ADDENDUM No. 4

Project Name: Todd Lane Improvements from Ben White to Saint Elmo

C.I.P. No. 6755.002

This Addendum forms a part of Contract and clarifies, corrects or modifies original Bid Documents, dated February 25, 2013. Acknowledge receipt of this addendum in space provided on bid form. Failure to do so may subject bidder to disqualification.

SHEET NUMBER 91 OF 175

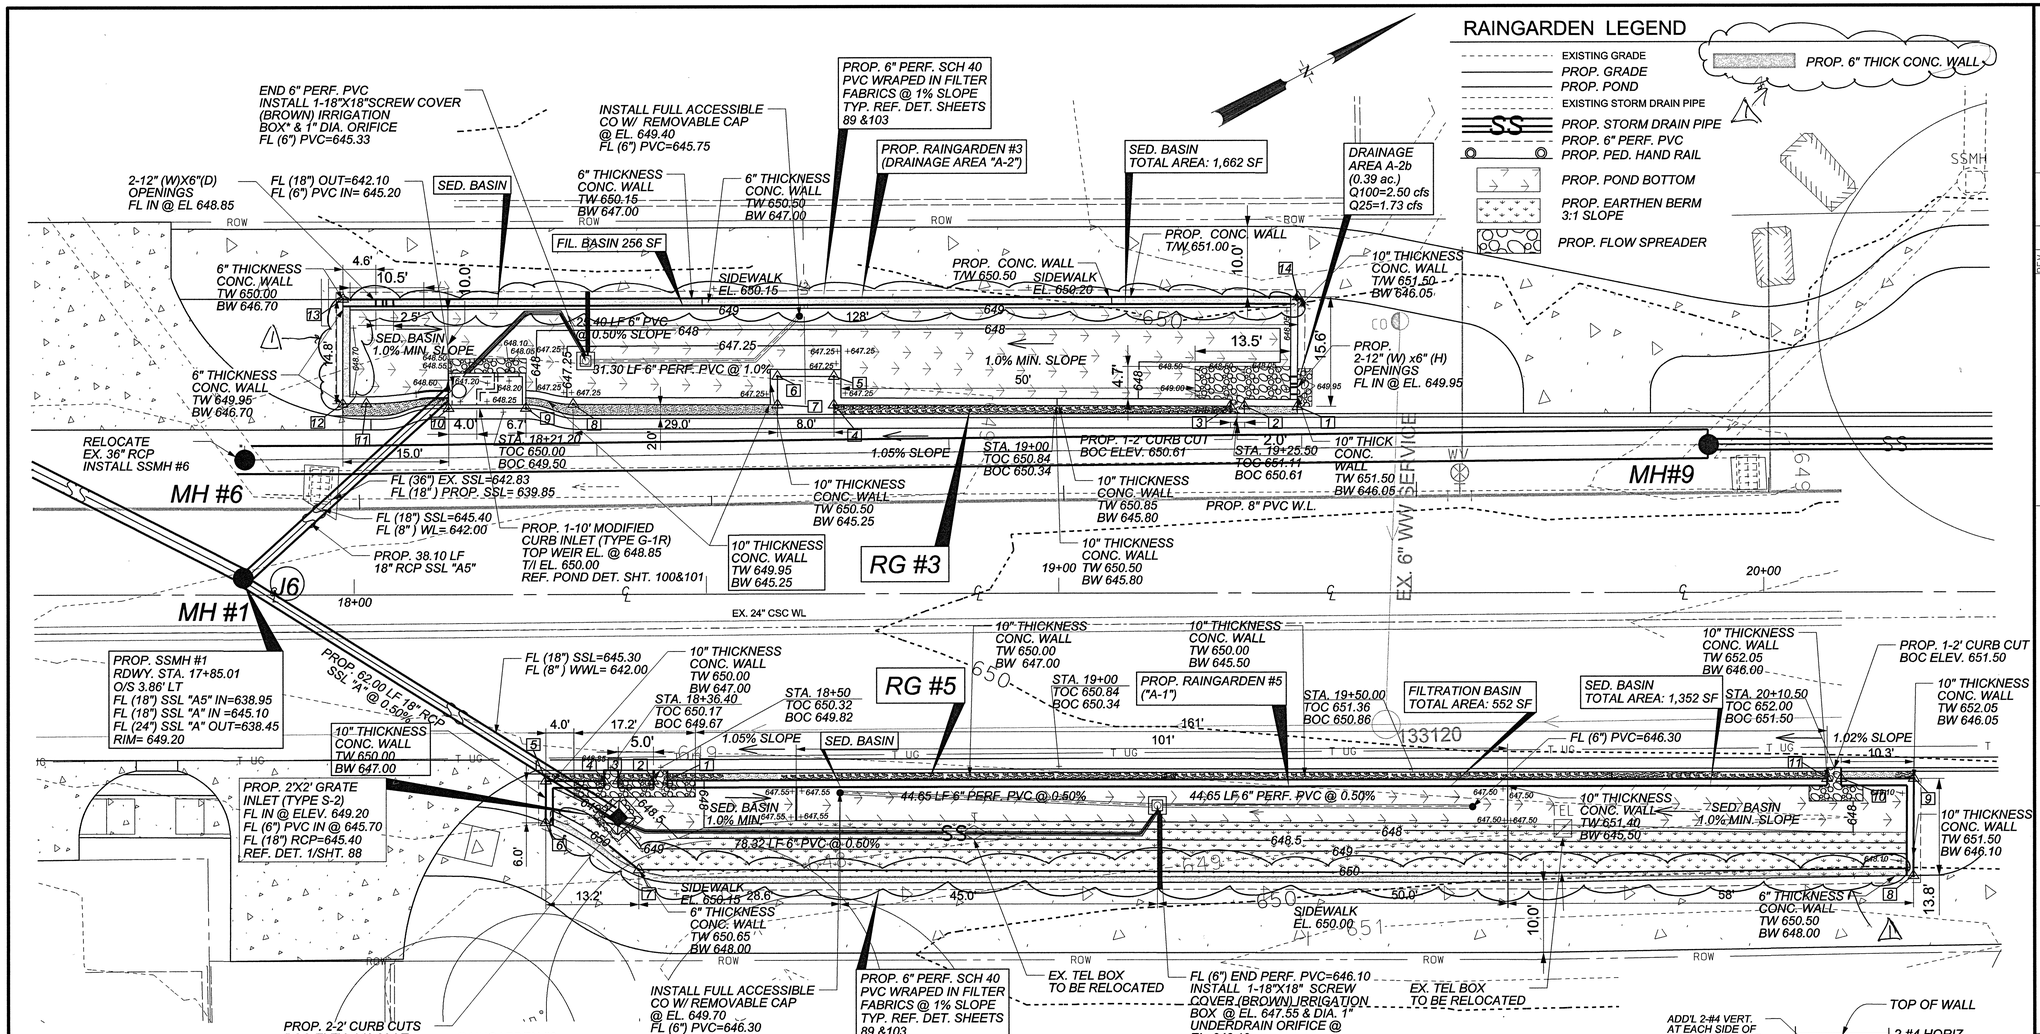
REV. NO.	BY	DATE	REVISION DESCRIPTION
R1	EZ	04/22/13	REVISED 6" THICK CONC. WALL - ADDENDUM #4

SHEET NUMBER 92 OF 175

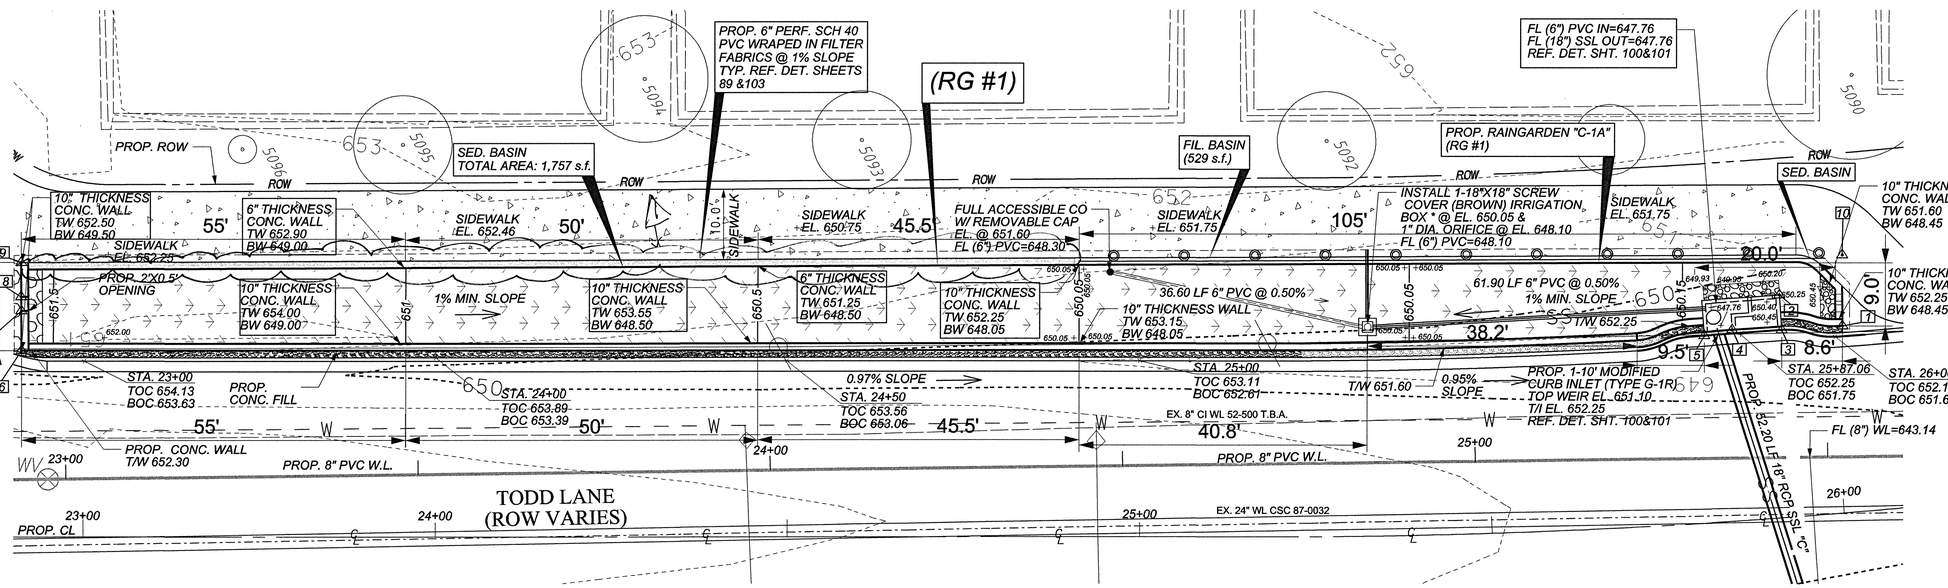
REV. NO.	BY	DATE	REVISION DESCRIPTION
1	EZ	04-22-13	ADDED 6" CONC. WALL SHADING - ADDED D.I. IN #4.

SHEET NUMBER 93 OF 175

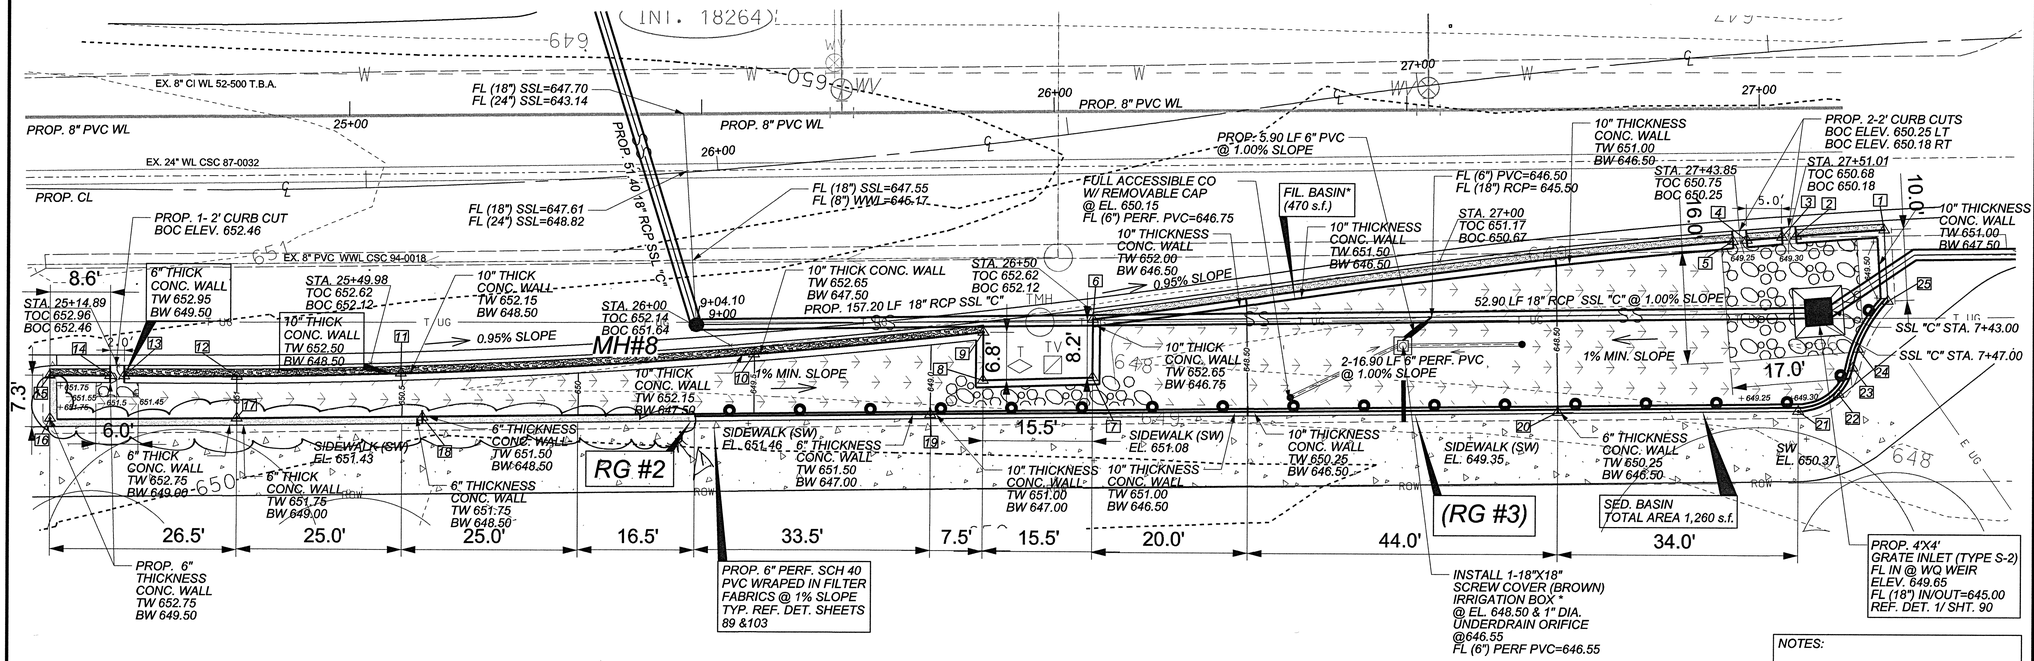
REV. NO.	BY	DATE	REVISION DESCRIPTION
1	EZ	04-22-13	ADDED 6" CONC. WALL SHADING - ADDENDUM #4

SHEET NUMBER 102 OF 175

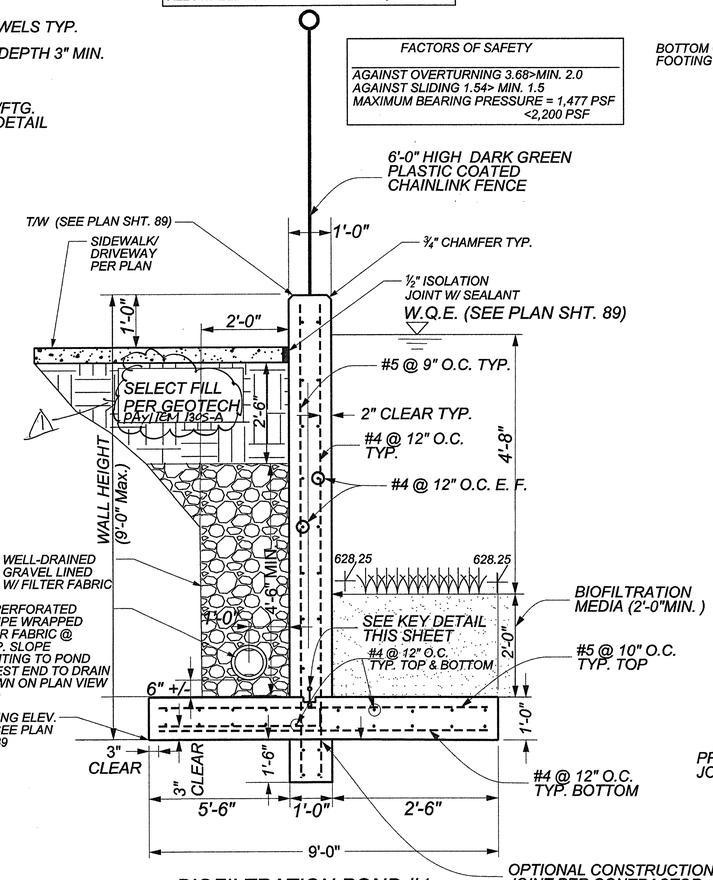
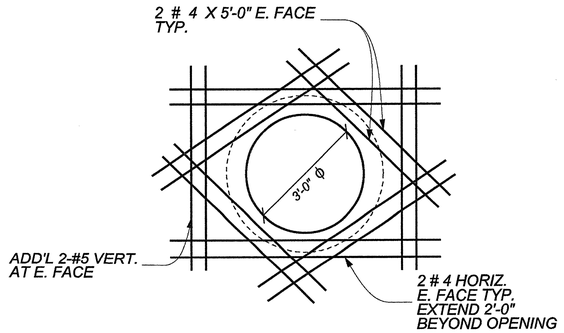
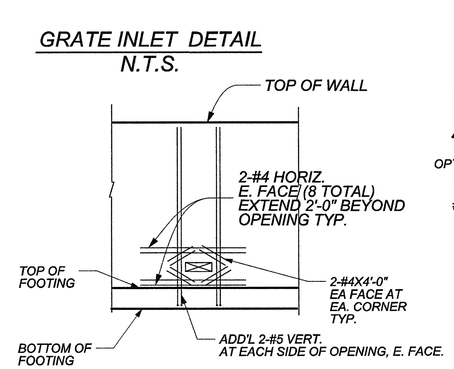
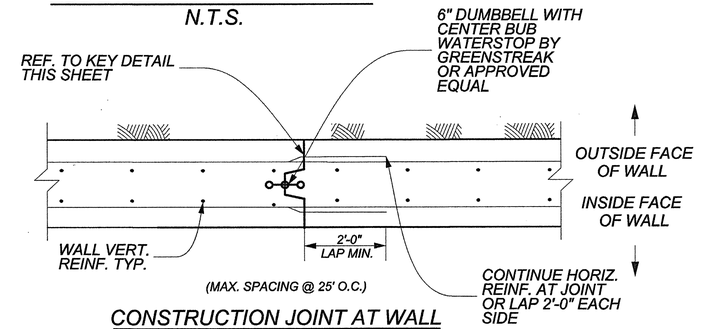
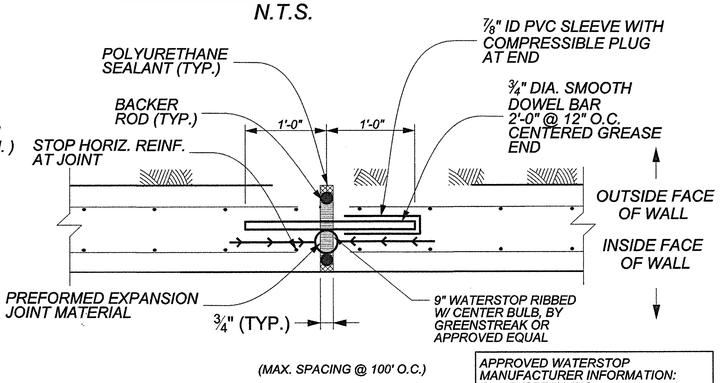
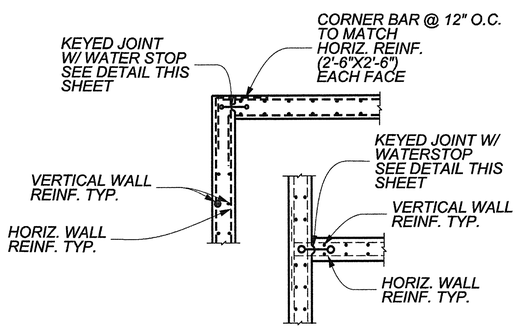
REV NO.	REV BY	DATE	REVISION DESCRIPTION
1	EZ	04/22/13	REVISED NOTE ADDED W/ #4

SHEET NUMBER 103 OF 175

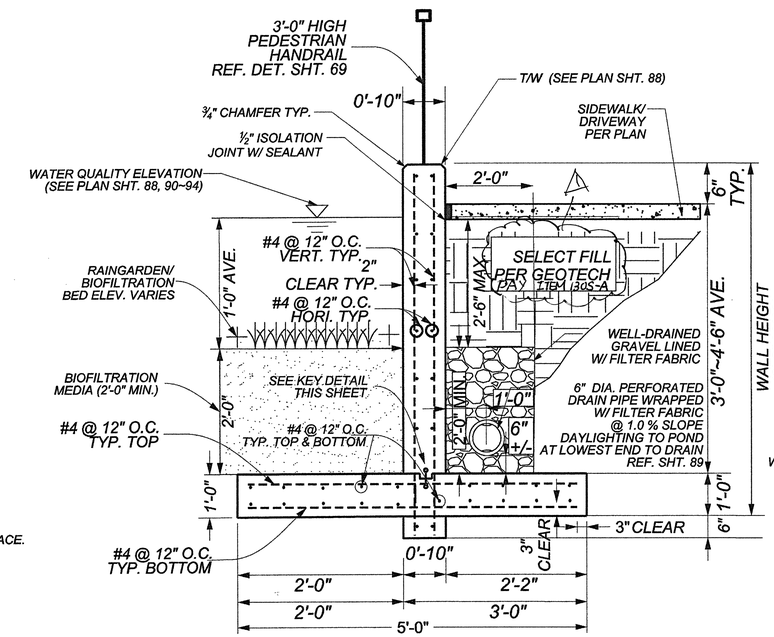
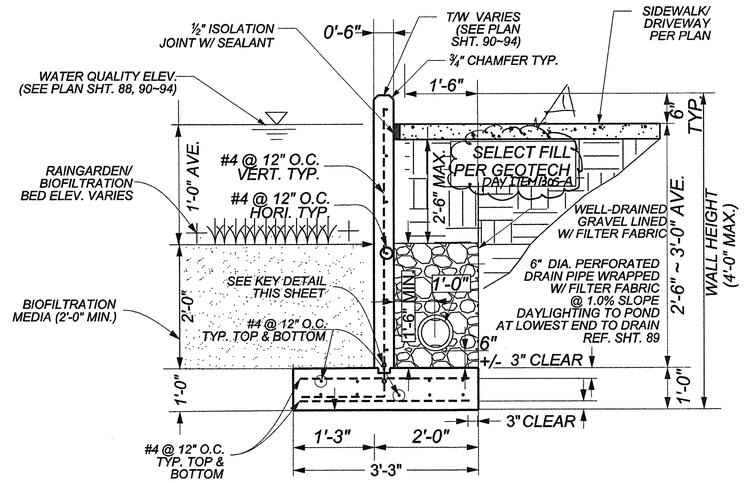
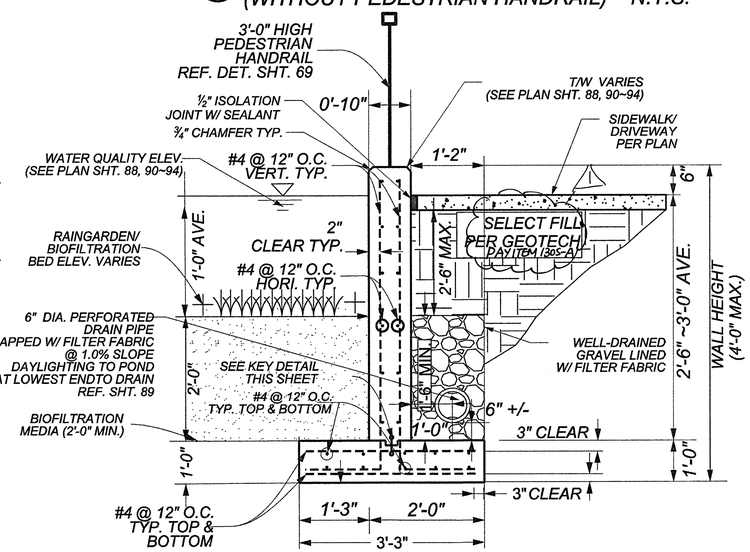
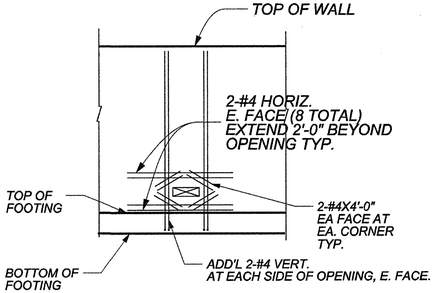
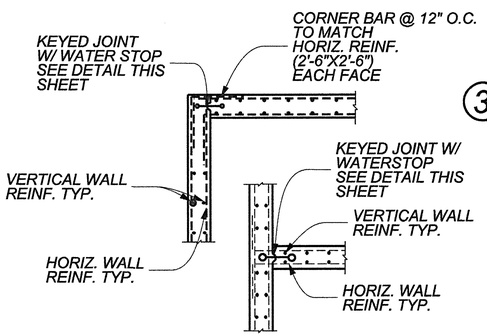
REV. NO.	BY	DATE	REVISION DESCRIPTION
1	EZ	04/27/13	REVISED NOTES - ADDENDUM #1
